No.	REVISION	DATE
	BY	
<p>EES ENGINEERING AND SOLUTIONS, INC. 501 S Cherry St, Suite 300 Denver, CO 80246 303.572.1997 www.eesusa.com</p>		
<p>SITE PLAN LOT 1 CONVENIENCE STORE CHAMBERS AND HESS PARKER, CO LANDSCAPE PLAN</p>		
PROJECT NO:		TSD003.01
DESIGNED BY:		LCG
DRAWN BY:		JLG
DATE:		05/18/21
L1.1

SITE PLAN LOT 1  
**CONVENIENCE STORE**  
CHAMBERS AND HESS, PARKER, CO  
**LANDSCAPE NOTES AND DETAILS**

### 1 LANDSCAPE PLAN

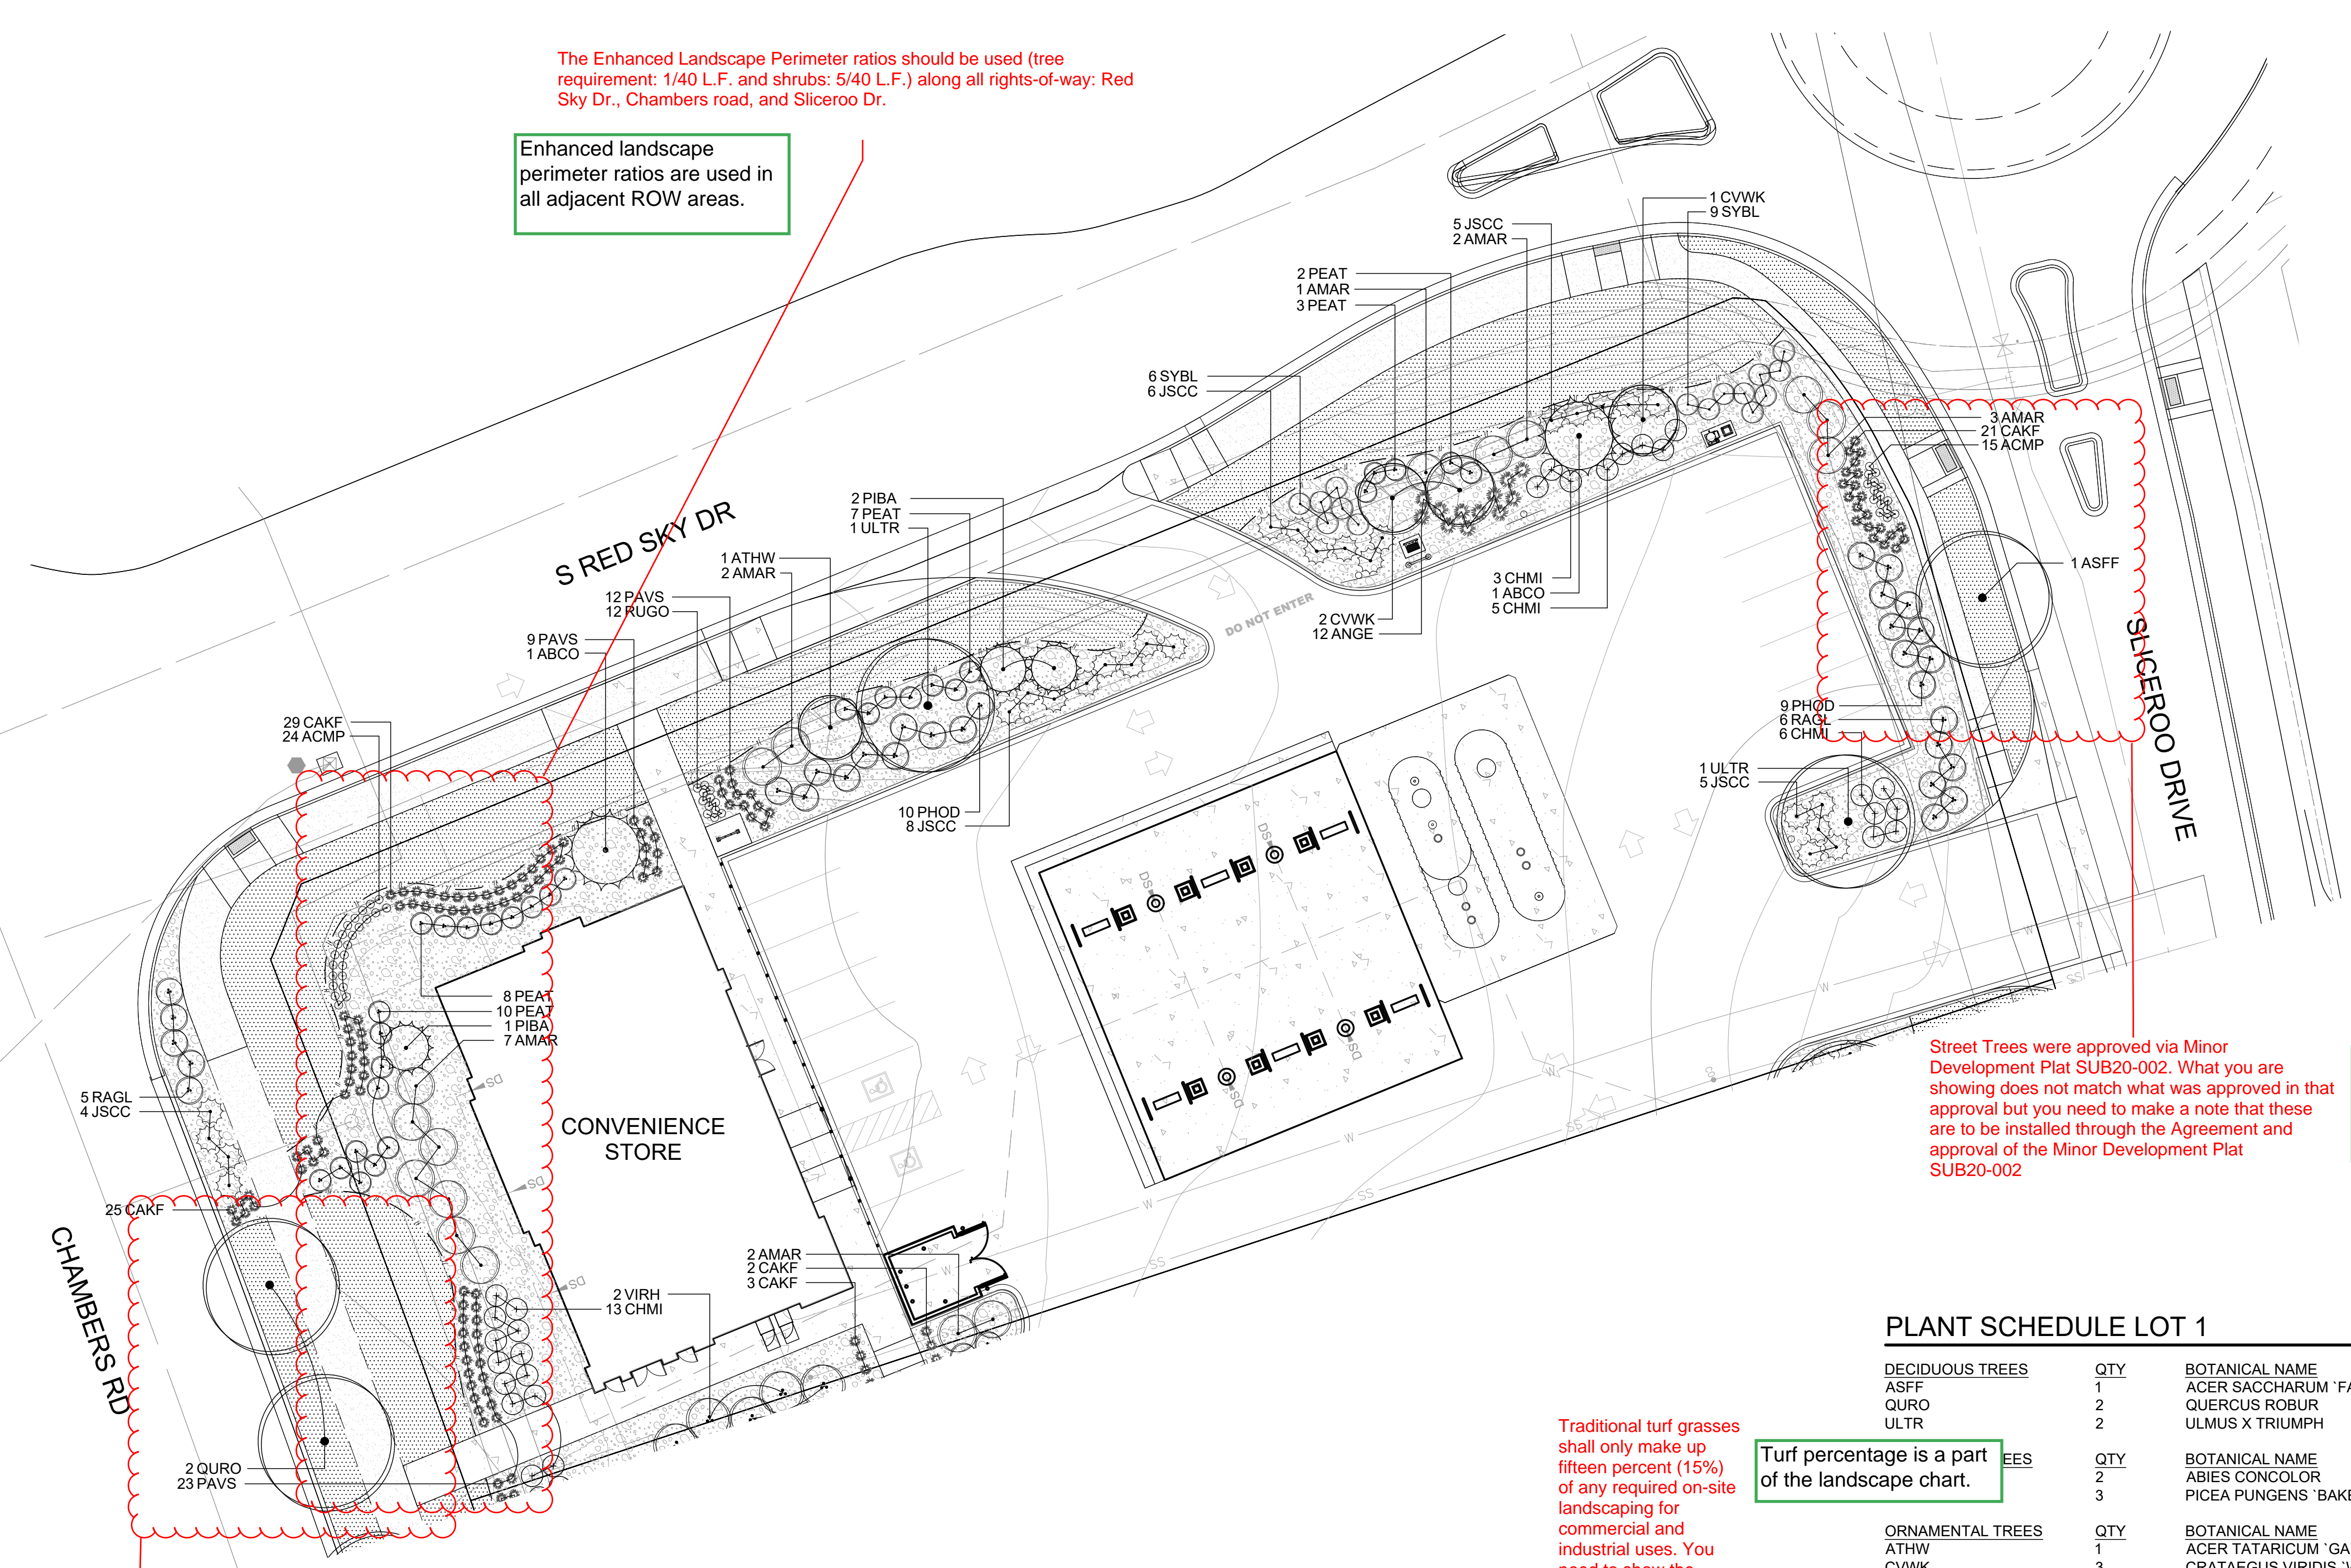
The Enhanced Landscape Perimeter ratios should be used (tree requirement: 1/40 L.F. and shrubs: 5/40 L.F.) along all rights-of-way: Red Sky Dr., Chambers road, and Sliceroo Dr.

Street Trees were approved via Minor Development Plat SUB20-002. What you are showing does not match what was approved in that approval but you need to make a note that these are to be installed through the Agreement and approval of the Minor Development Plat SUB20-002

Traditional turf grasses shall only make up fifteen percent (15%) of any required on-site landscaping for commercial and industrial uses. You need to show the Percentage and compliance.

- Call out for size to show how you get 15%
- Break out the required Streetscape Landscaping-no further that 1 tree ever 40' apart
- Need to break out Parking Lot Perimeter Landscaping
- See example chart provided on referral notes.
- Math needs to be shown for all calcs. of how you get to the required percentages

Street Trees were approved via Minor Development Plat SUB20-002. What you are showing does not match what was approved in that approval but you need to make a note that these are to be installed through the Agreement and approval of the Minor Development Plat SUB20-002

Enhanced landscape perimeter ratios are used in all adjacent ROW areas.

ROW Landscape has been removed and a note has been added referencing MDP SUB20-002.

Turf percentage is a part of the landscape chart.

The landscape chart has been revised per the example given.

ROW Landscape has been removed and a note has been added referencing MDP SUB20-002.

### PLANT SCHEDULE LOT 1

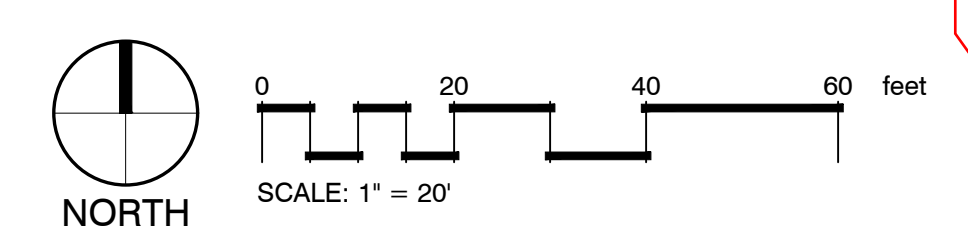
Include Maturation Heights  
Height and spread has been added
